Re: Clean Copies
Abandonment of Well S-2-GW
Savage Services Corporation
Savage Coal Terminal
C/007/0022 , Task ID #4491

Permittee: Savage Services Corporation
Mine: Savage Coal Terminal **Permit Number:** C/007/0022
Title: Clean Copies per Conditional Approval - Removal of Ground Water Monitoring Well S-2-GW

Appendix 7-4
Justification to Remove
Groundwater Monitoring Well S-2-GW

SAVAGE COAL TERMINAL
 RECLAIMED GROUNDWATER WELL
 LOCATION MAP

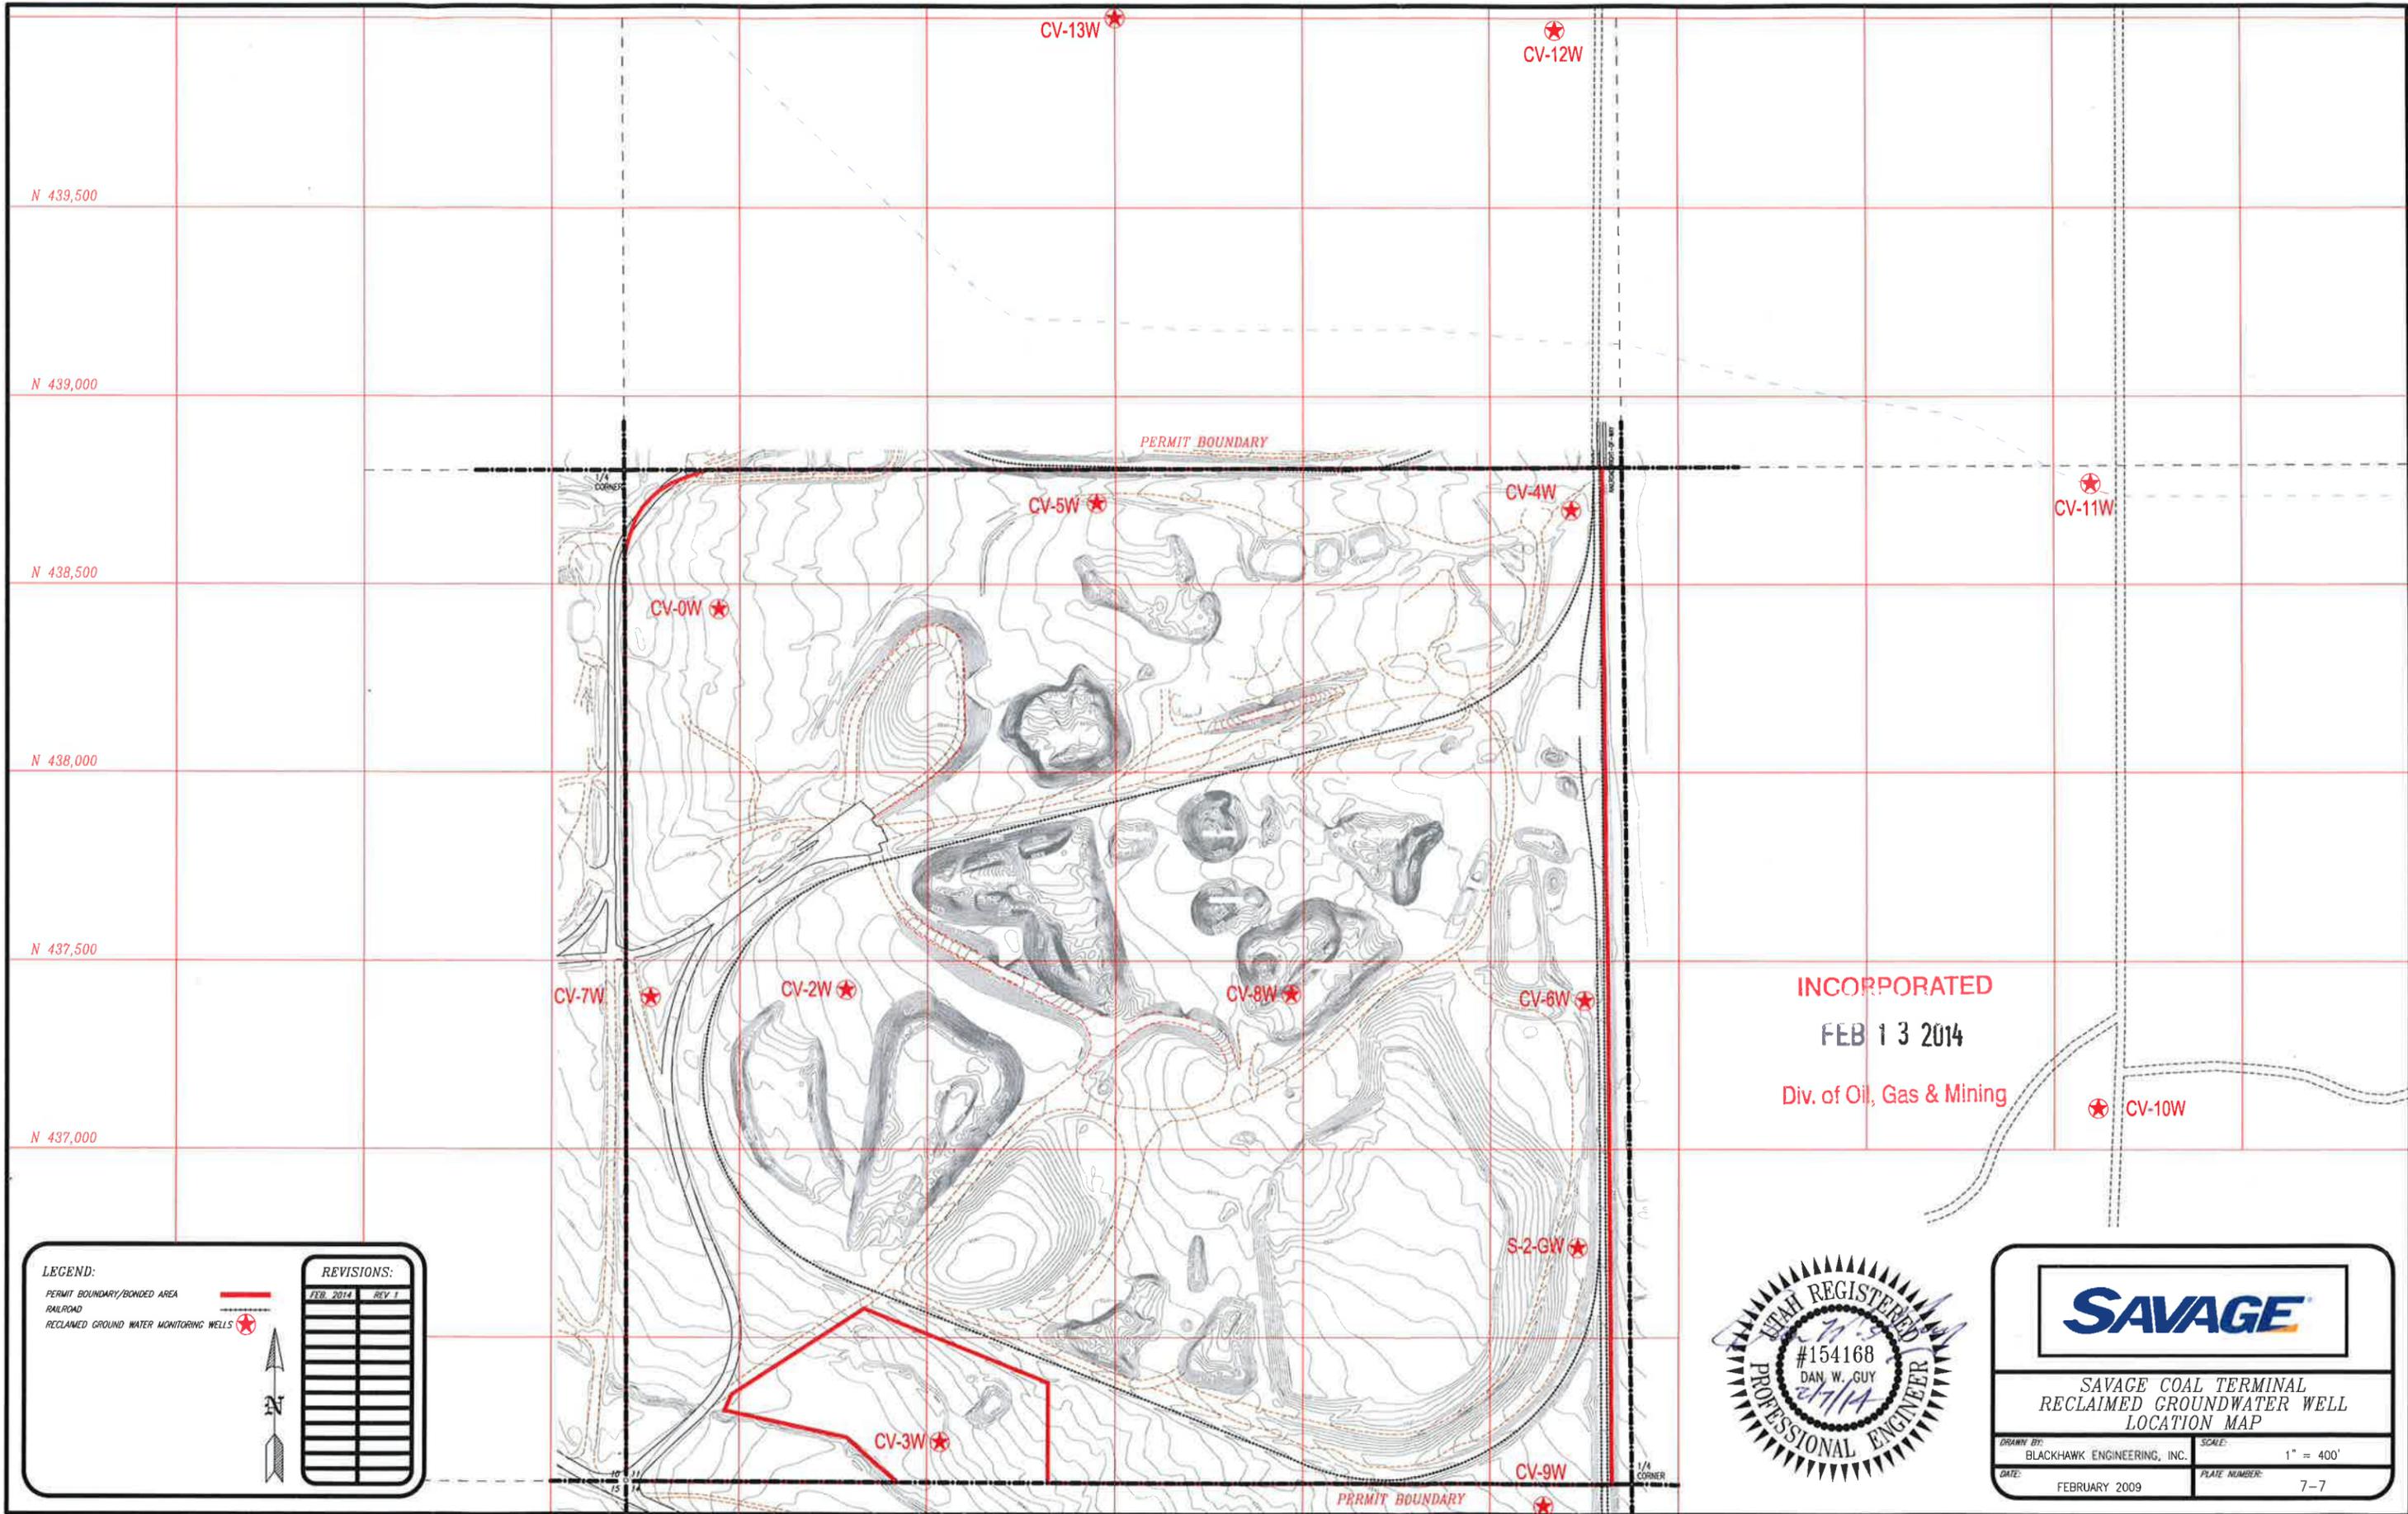
The only proposed change to the present system will be the removal of well S-2-GW, as previously mentioned. Wells S-1-GW and S-3-GW will continue to be monitored according to the approved plan.
